PD Modification Application: MM 22-1116

Zoning Hearing Master Date: April 17, 2023

Hillsborough
County Florida

Development Services Department

PLANNED DEVELOPMENT SITE PLAN

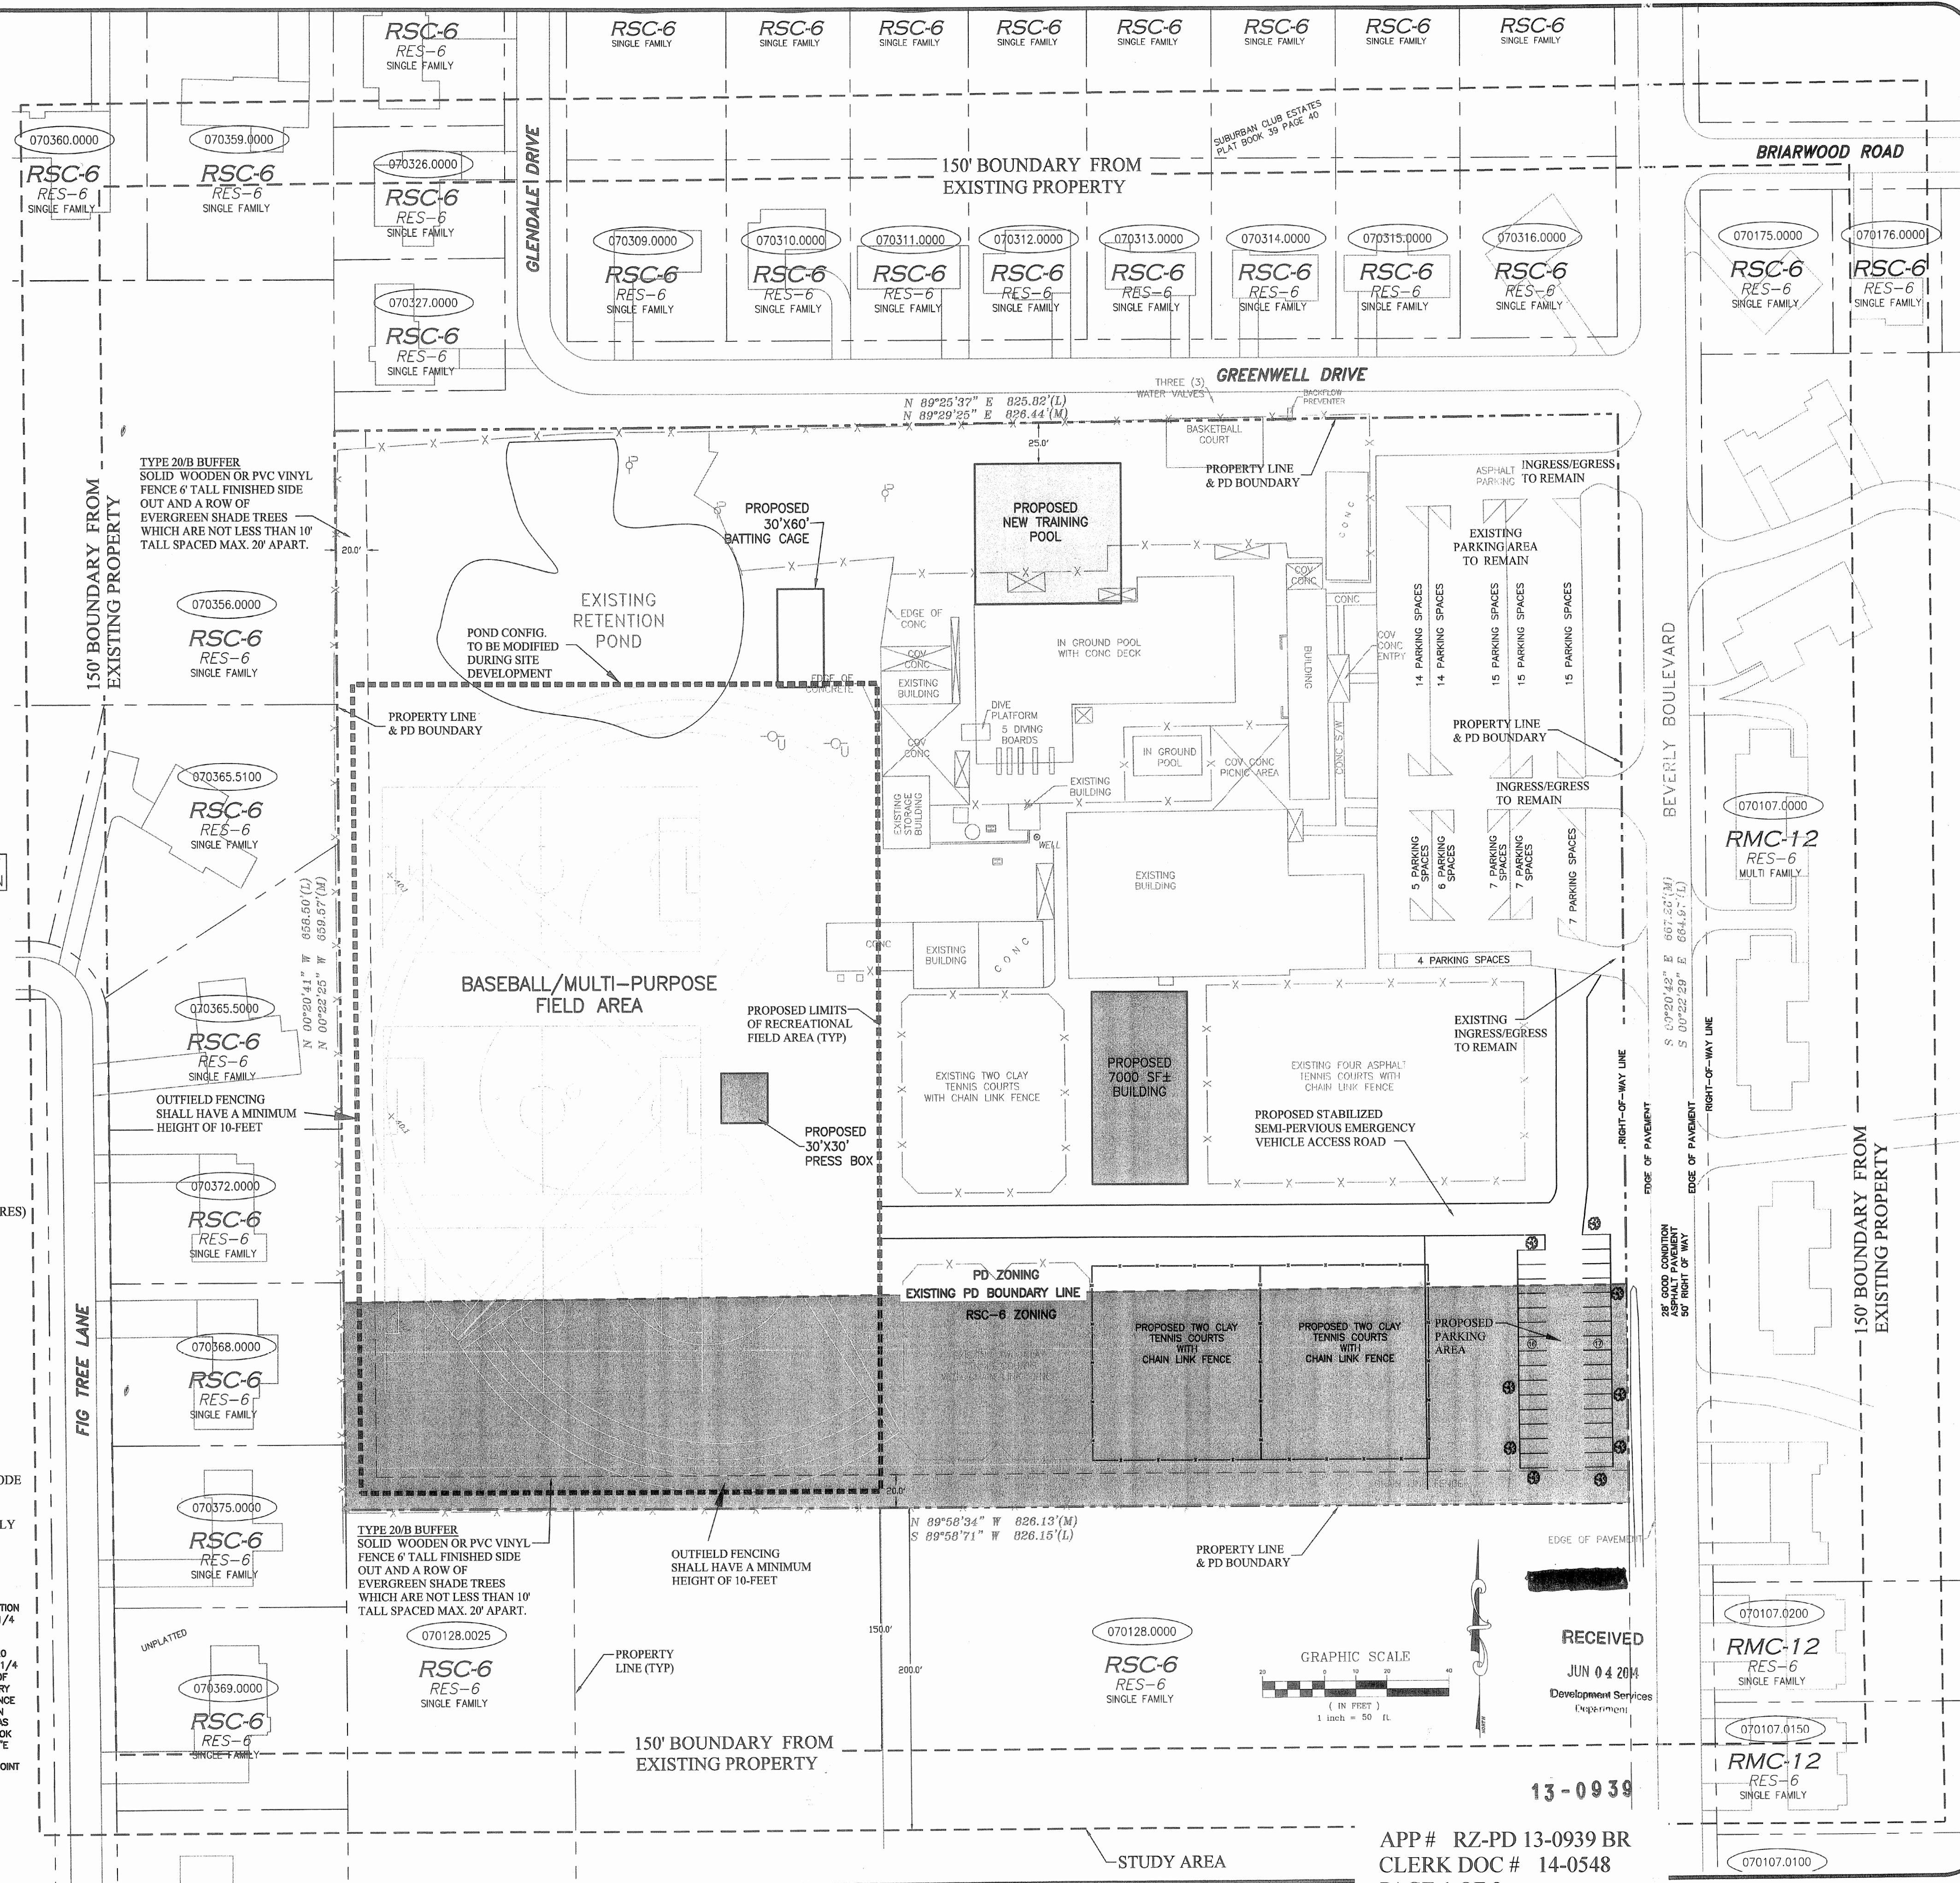
- Include the existing approved site plan, labeled as “Option A – Planned Development Site Plan”;
- Include the latest site plans of record (labeled as Sheets 1, 2 and 3) as follows:
 - Sheet 1 of 3, “Option B – Planned Development Site Plan”;
 - Sheet 2 of 3, “Option B – Queuing Plan”; and,
 - Sheet 3 of 3, “Option B –Regular/Event Parking Plan”
- On Sheet 3, replace the footnote under the parking table with a note which reads

“*ALTERNATIVE PARKING STANDARD APPROVED VIA PD VARIATION PROCESS CONCURRENTLY WITH MAJOR MODIFICATION #22-1116 – SEE CONDITIONS OF APPROVAL”.

QUEUING PLAN

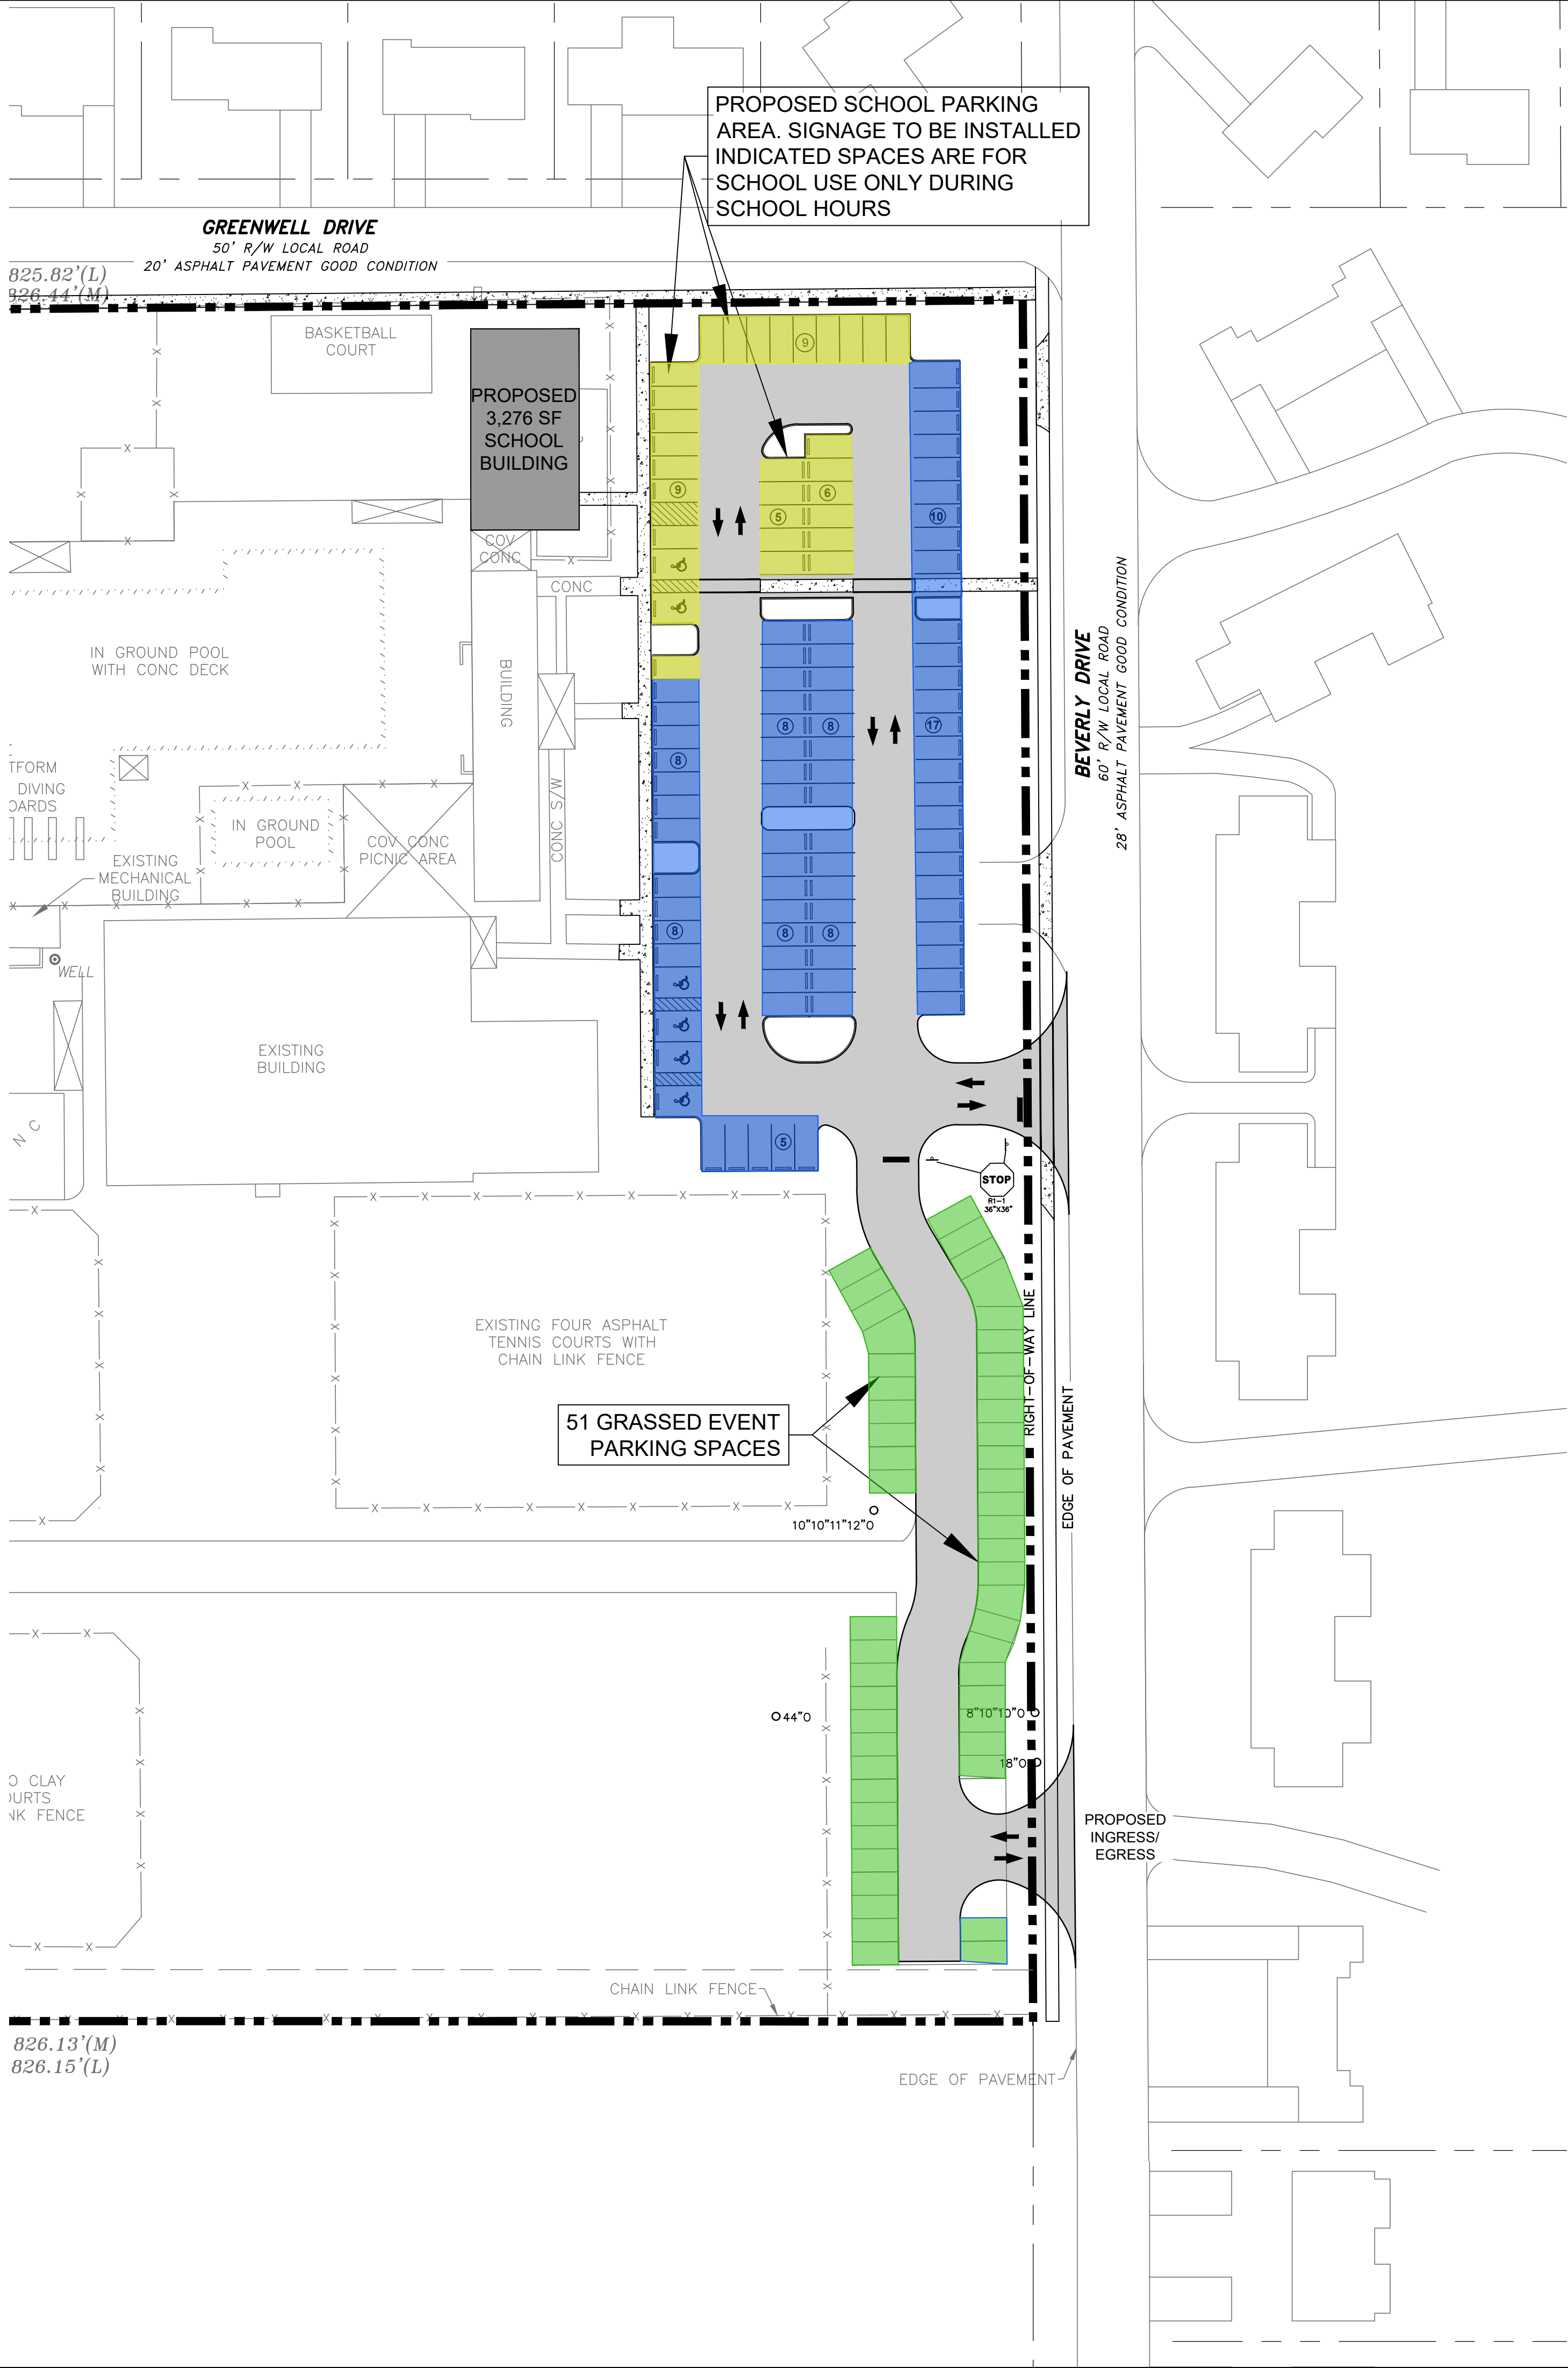
6. Access management, vehicle queuing, and staff placement shall occur consistent with the Queuing Plan (Sheet 2 of 3). Modifications to these plans may be submitted in accordance with Condition 3, above, or as otherwise approved by Hillsborough County Public Works.

The applicant submitted a traffic circulation plan (Sheet 2 of 3) which illustrates the flow of traffic during drop-off and pick-up periods, and appears to be consistent with Sec. 6.03.13 requirements governing required vehicular queuing. Vehicles entering the site for the general purpose recreational uses will use the northernmost entrance during drop-off and pick-up periods. All school traffic will enter the site utilize the southernmost entrance, during drop-off and pick-up periods. The developer's parking plan (sheet 3 of 3) includes parking indicates that the project will meet Sec. 6.05 parking requirements, and places restrictions on certain spaces such that they are reserved for school use only during school hours. Consistent with Sec. 6.03.13.C. of the LDC, the parking plan also indicates an area for up to 51 additional grass overflow parking spaces, which may be used for school events.
